RE: Report on Quarterly Groundwater Monitoring
1825 Park Street, Alameda, California
Project No. 94-6089-1.1

QUARTERLY GROUNDWATER MONITORING
REPORT
1825 PARK STREET
ALAMEDA, CALIFORNIA

October 1995
Job Number 94-6089-1.1

Figure No. 3

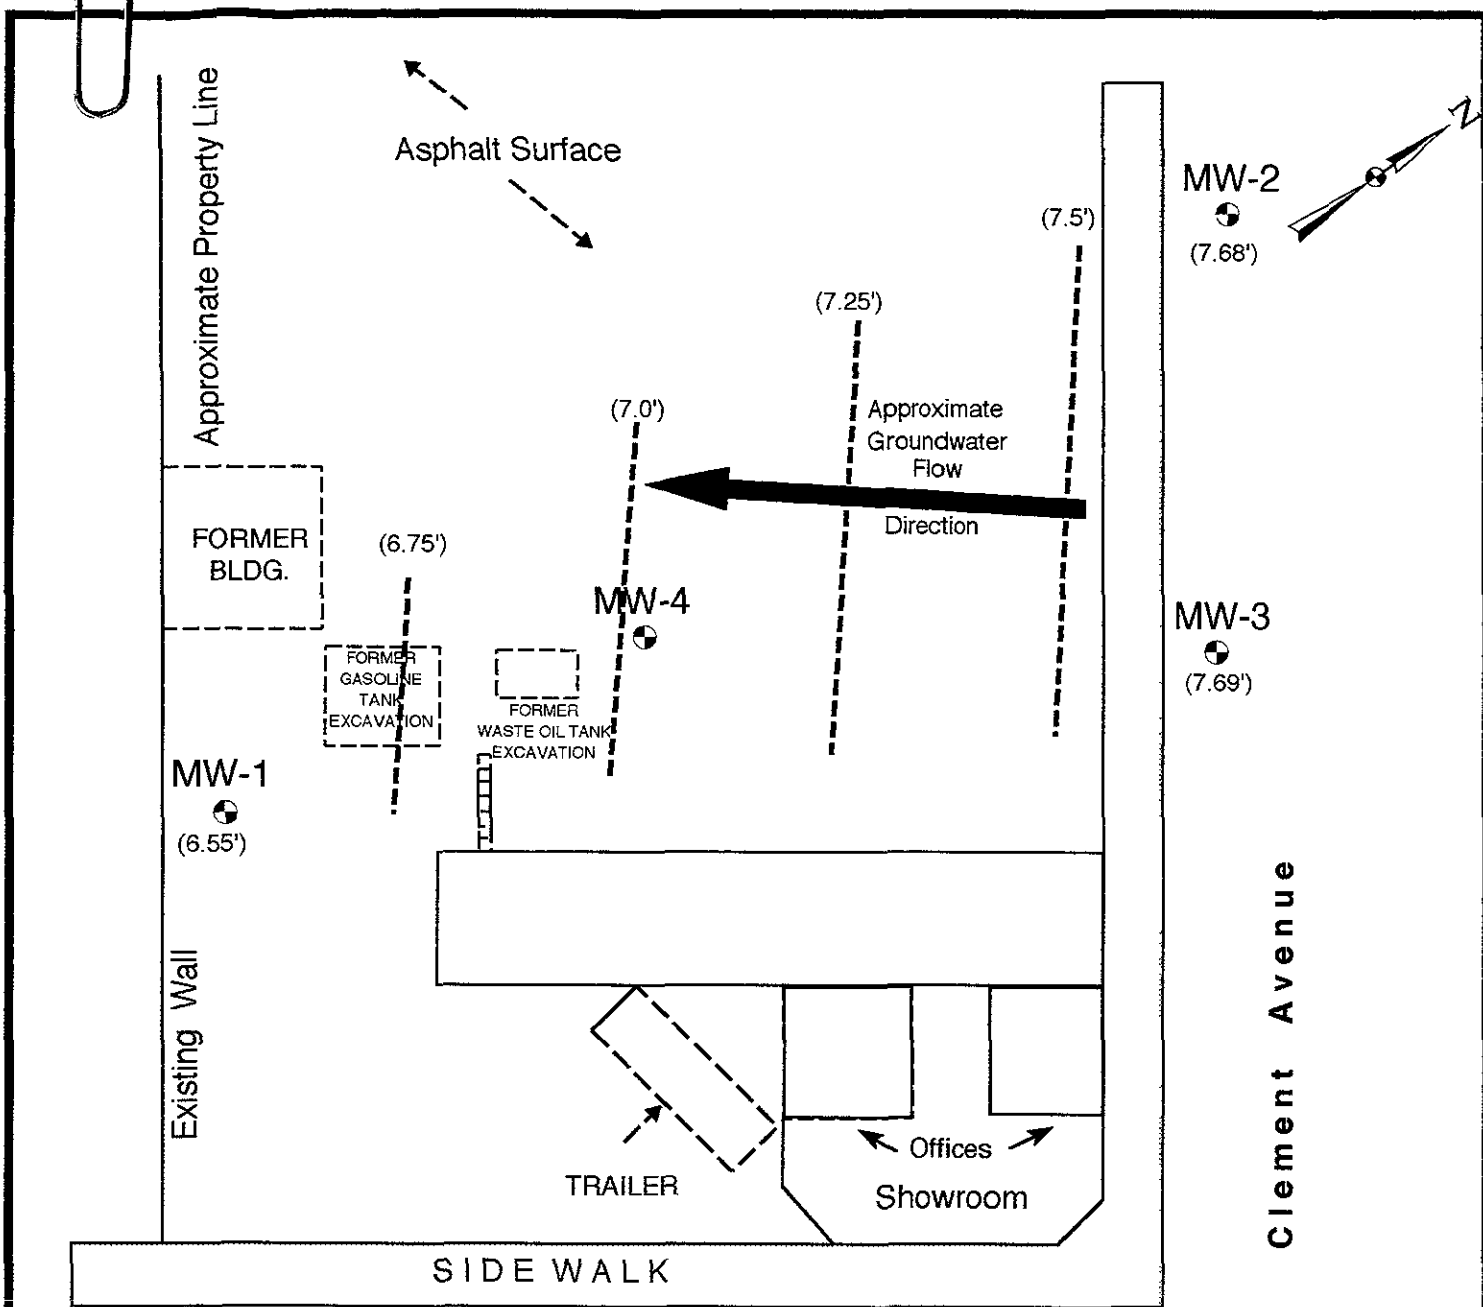
NI fig. enclosed

*Change in GW flow direction
may be due the fact that
well MW-2 was damaged
during street paving.*

Attached please find copies of Figures 1-3, which were missing from your copy of the September 1995 Quarterly Monitoring report for the subject site. Due to groundwater elevation agreement with MW-3 (also in Clement Street) and our technician's observation that the depth to water measurement in MW-2 was made from PVC that appeared to be at the original elevation, ACC maintains the gradient and flow direction illustrated on Figure 3 was correct on that date. Despite the damage to the top of well MW-2, our technician was confident in his depth to water measurement.

The reason for the change in calculated flow direction is unknown. It is possible that the depth to water measurement in MW-1 was incorrect but the technician claims he measured water in the wells as he has always done during past sampling events. Upcoming monitoring should help confirm groundwater flow direction.
